PROJECT: Elkhorn 40-Residential Development

SUBMITTAL: 3rd Submittal

CITY OF LAS VEGAS		DATE:
INTER-OFFICE MEMORANDUM		February 1, 2017
TO: Land Development Services Department of Building & Safety		FROM: Albert Sung, P.E. Flood Control Project Engineer Department of Public Works
SUBJECT:	Drainage Study for:	
	Elkhorn 40 – Residential Development	
Cross Streets:	SEC of Elkhorn Road & Tenaya Way	
File Number:	F:\Depot\DSMemos\DS4823C.doc	
Parcel Number:	125-22-501-001	
Zoning Action:	TMP-65275; ZON-63488; WVR-65331; WVR-65593 & Variances	
FEMA Flood Zone	YES	NO X
Proposed Storm Drain	YES	NO X
COPIES TO:		
		Triton Engineering
		D.R. Horton, Inc.
		Bart Anderson, P.E., DevCo
		CCPW

The Drainage Study for the subject project has been reviewed and:

GRADING PLAN 1

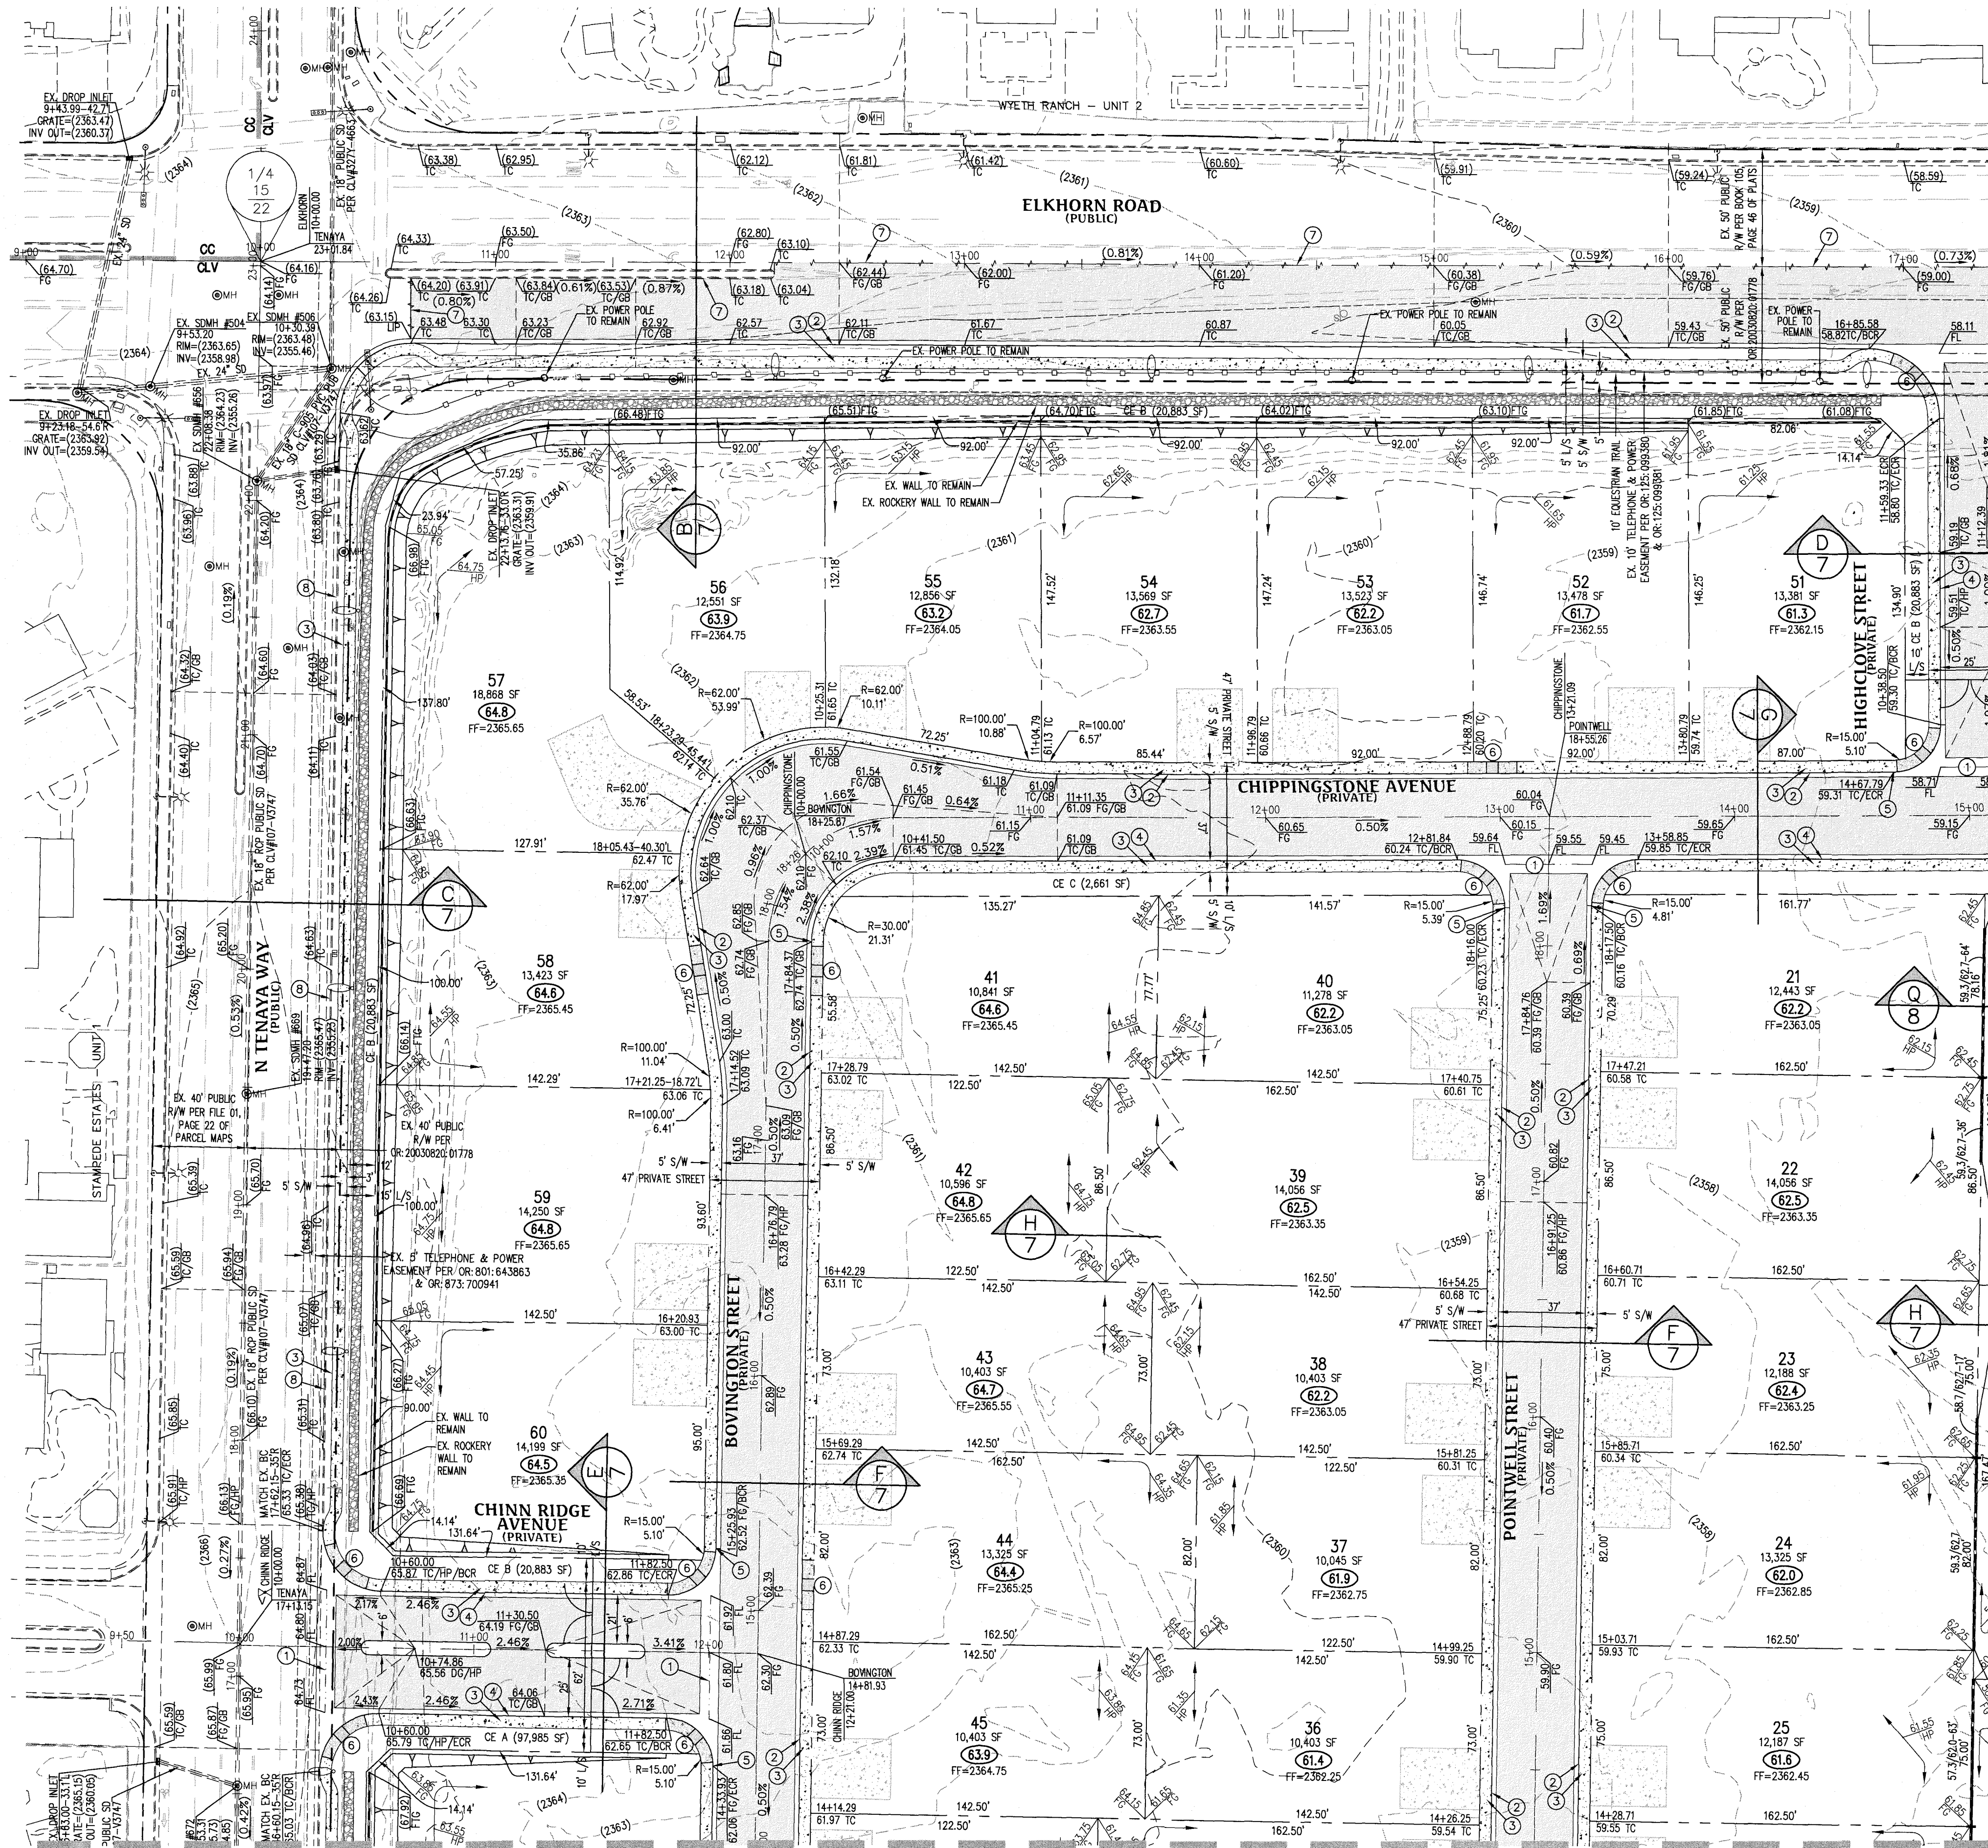
3. **Sheet 3 of 25 (Grading Plan 1):** Identify existing drop inlets in *Elkhorn Road* to the west of the intersection with *Tenaya Way*. Show the pertinent connection of the inlets with laterals to the storm drain manhole in the street intersection.

- 3. Sheet 3 of 25 (Grading Plan 1): Identify existing drop inlets in Elkhorn Road to the west of the intersection of Tenaya Way. Show the pertinent connection of the inlets with laterals to the storm drain manhole in the street intersection.**

SHEET 7 OF 26
C.L.V. DWG.#

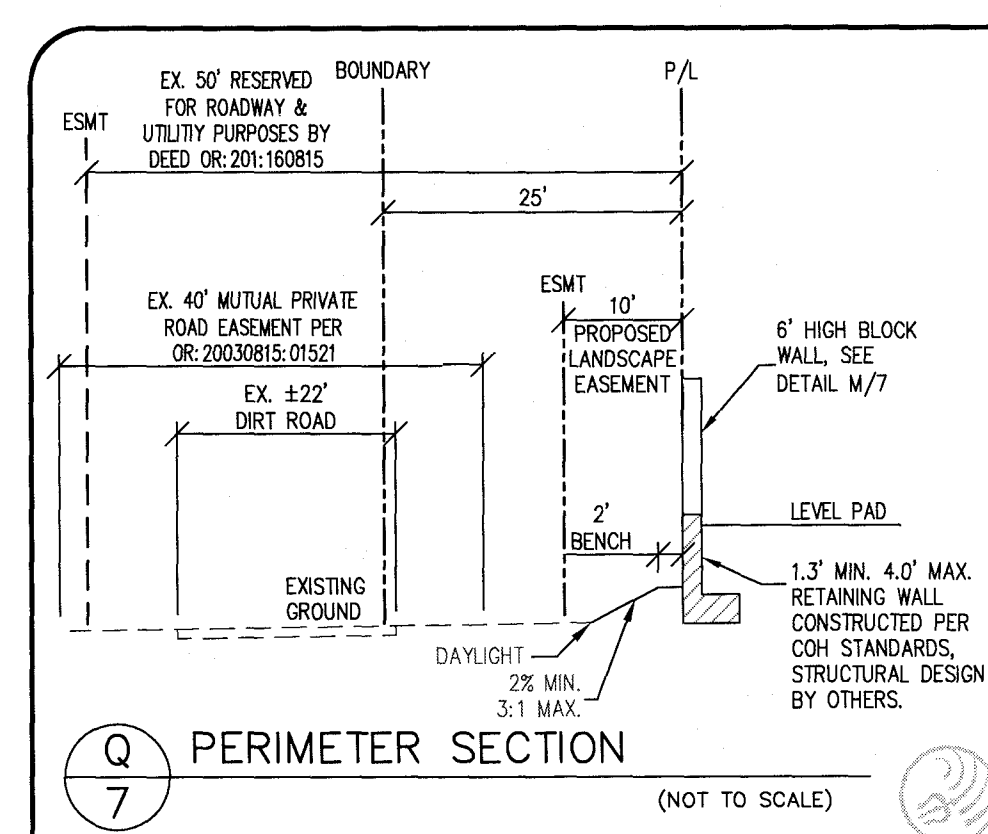
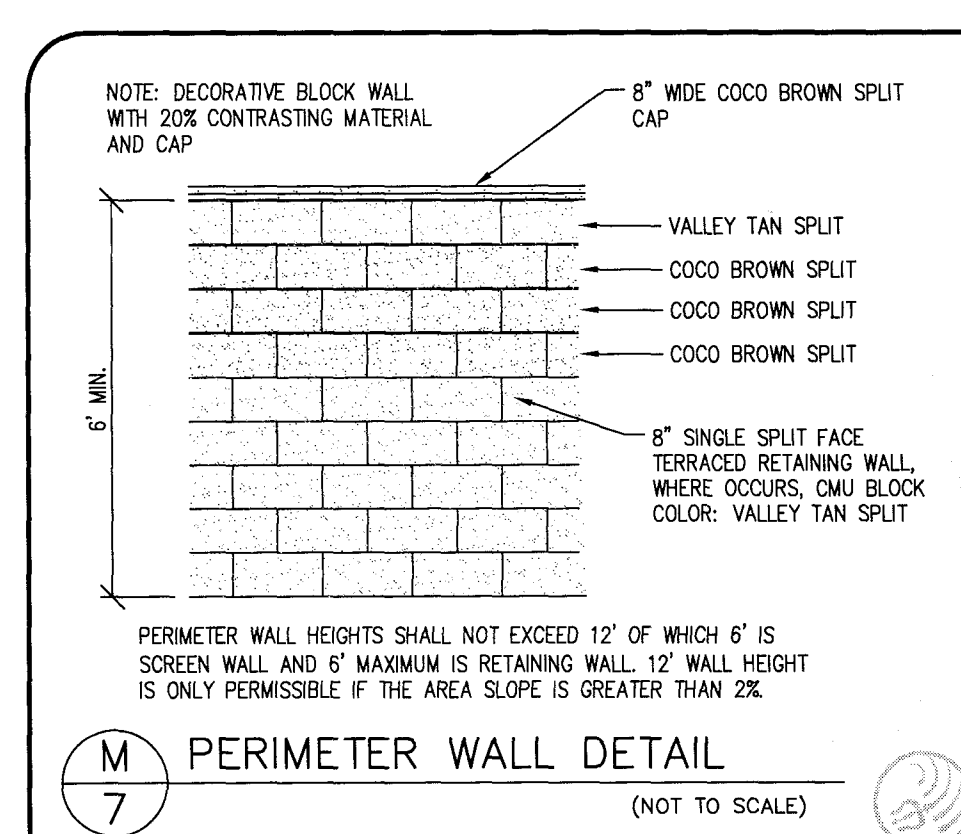
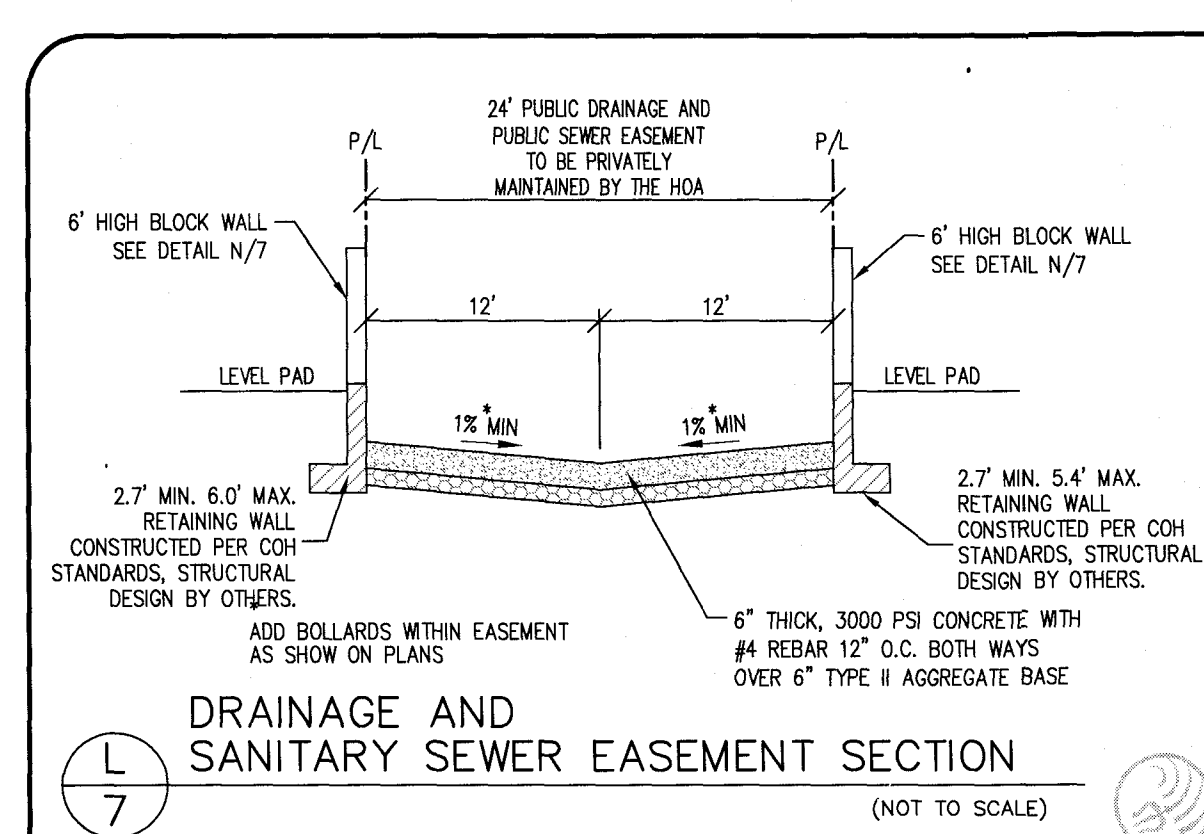
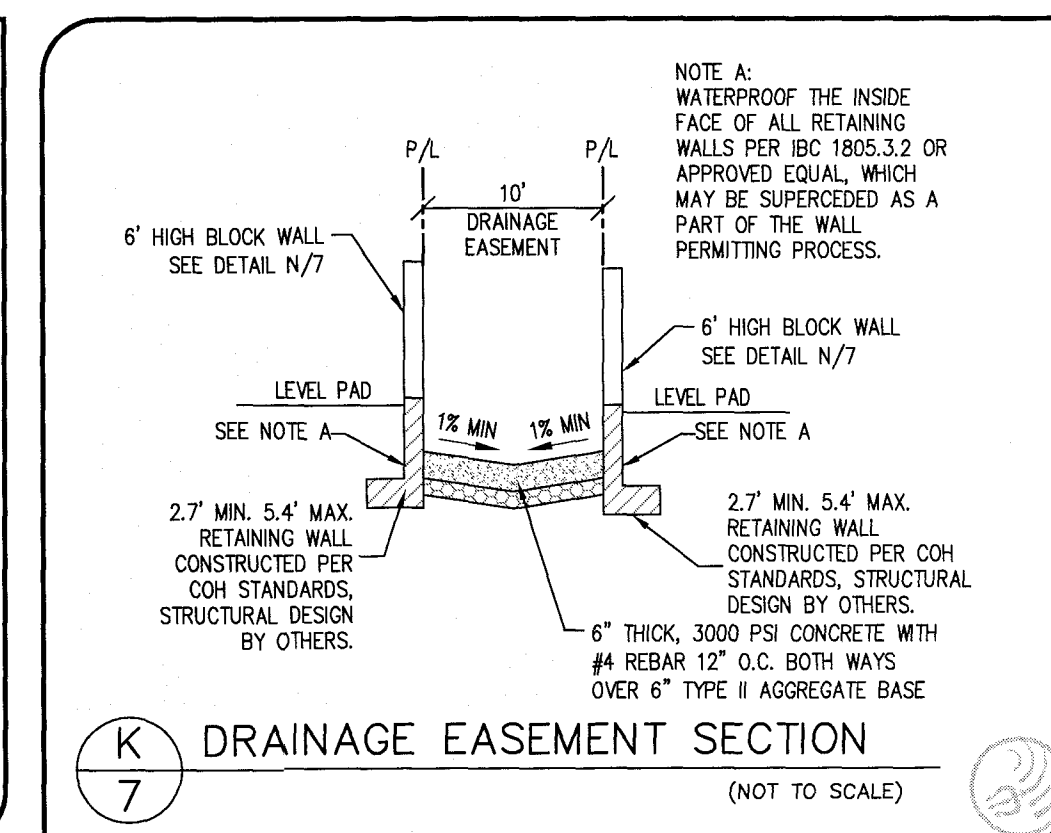
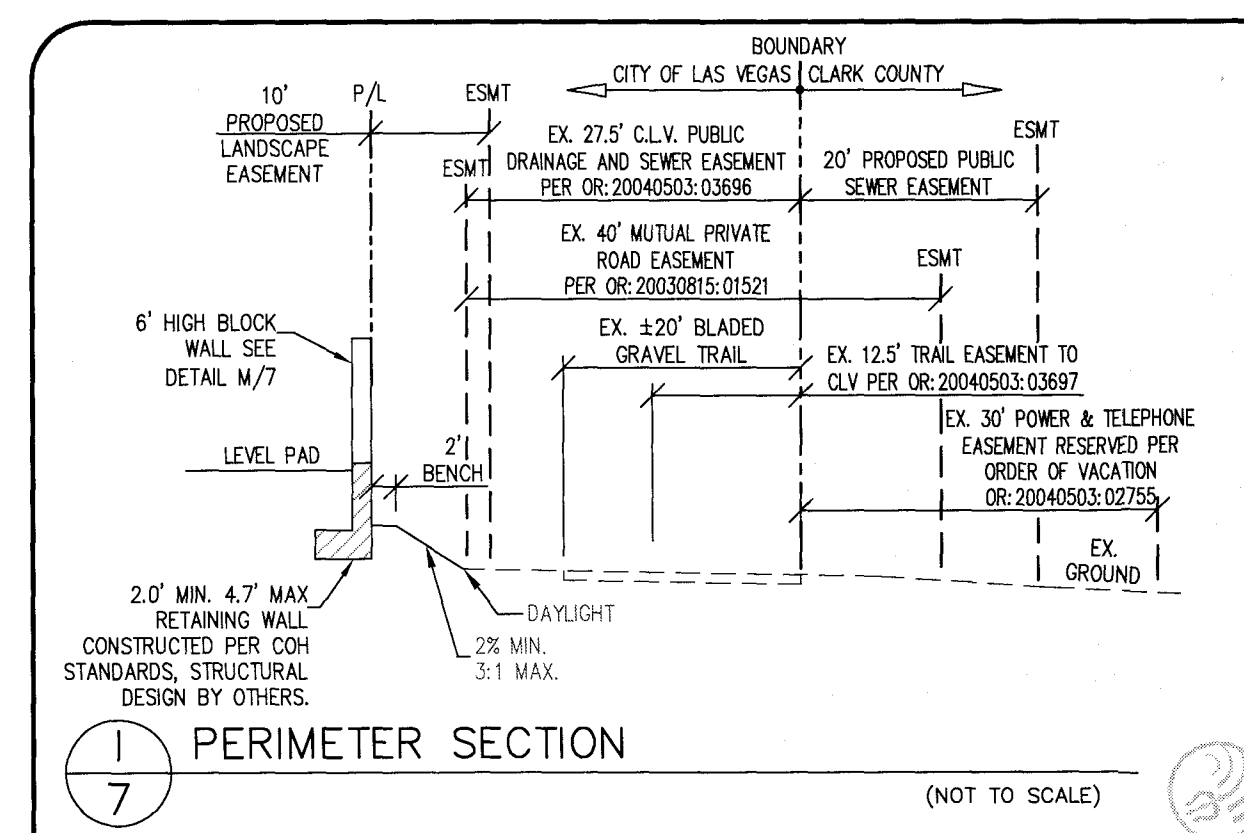
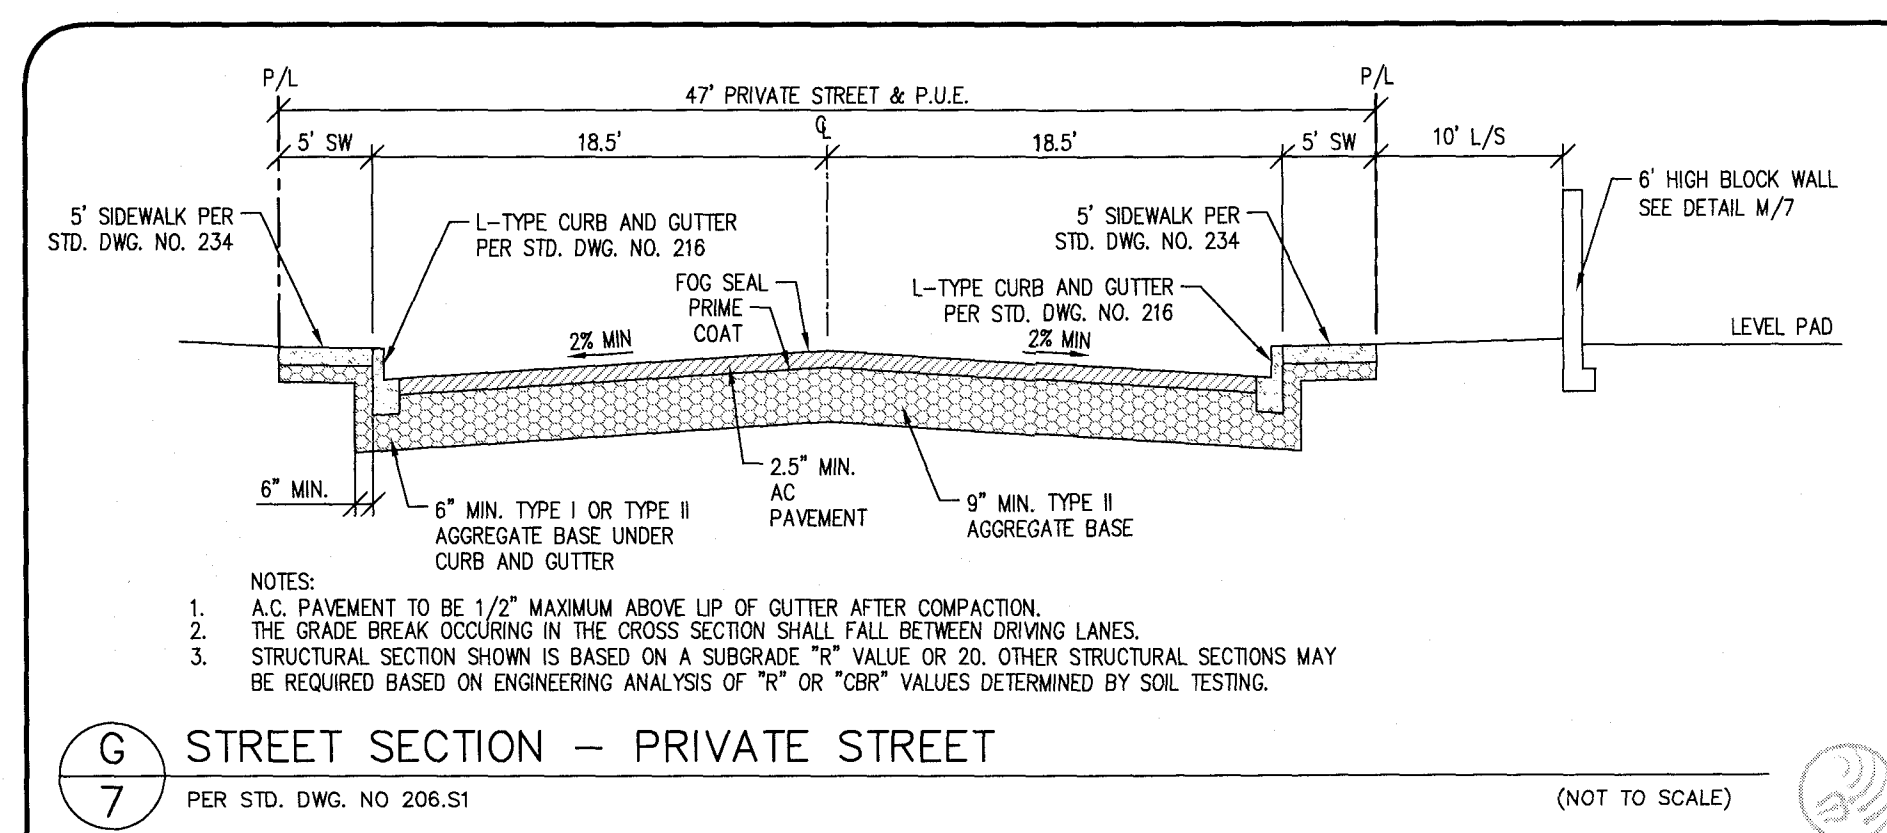
- A note on all the grading plans stated that "THIS PROJECT WILL BE CONSTRUCTED WITH CONTINUOUS R-TYPE CURB ON THE FRONTAGE OF ALL LOTS". However, the detail sheet (Sheet 7 of 26) shows L-curb to be constructed instead. Review and revise accordingly in the next submittal.
